DIMINISHMENT/CANCELLATION
of Water Rights Related To
Application G-16322
Permit G-15883
SEVEN HILLS PROPERTIES LLC
Revised 23 JUN 2009

T 10777

PERMIT AMENDMENT MAP
Application G-16322
Permit G-15883
SEVEN HILLS PROPERTIES
POA Location Amendment
Revised 23 JAN 2009

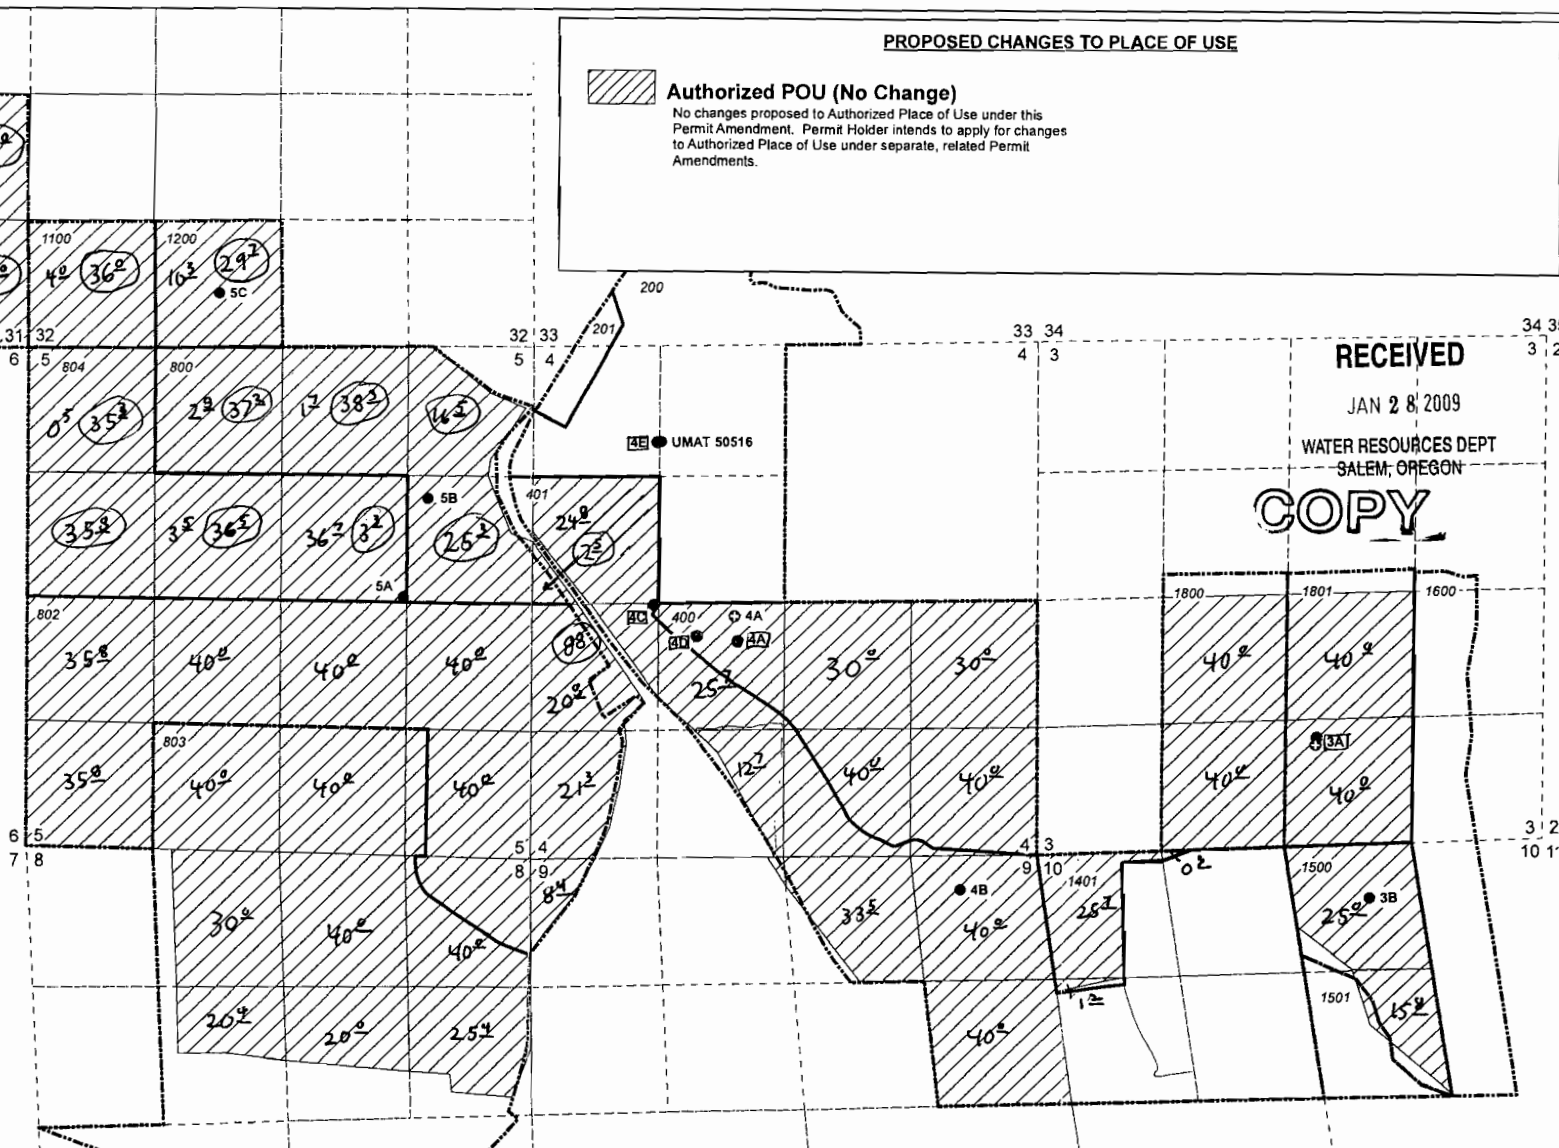
- **Authorized POA (Change FROM)**
POA 3A relocate from SW/4 SE/4, S3, T6N, R35E, WM, 2900 feet E and 1225 feet N from SW Corner S3.
POA 4A relocate from NE/4 SW/4, S4, T6N, R35E, WM, 2960 feet S and 3140 feet W from NE Corner S4.

- **Proposed POA (Change TO)**
POA 3A relocate to SW/4 SE/4, S3, T6N, R35E, WM at a location 1156 feet N and 314 feet E from S/4 Corner S3 (Well Log UMAT 55526).
POA 4A relocate to NE/4 SW/4, S4, T6N, R35E, WM at a location 415 feet S and 500 feet W from Center S4 (Well Log UMAT 55523).

- **Proposed POA (Additional)**
POA 4C in NW/4 SW/4, S4, T6N, R35E, WM at a location 50 feet S and 1400 feet W from Center S4 (new, additional potential well site).
POA 4D in NE/4 SW/4, S4, T6N, R35E, WM at a location 375 feet S and 940 feet W from Center S4 (new, additional potential well site).
POA 4E in NW/4 NW/4, S4, T6N, R35E, WM at a location 335 feet S and 1466 feet E from NW Corner S4 (potential replacement of well UMAT 50516).
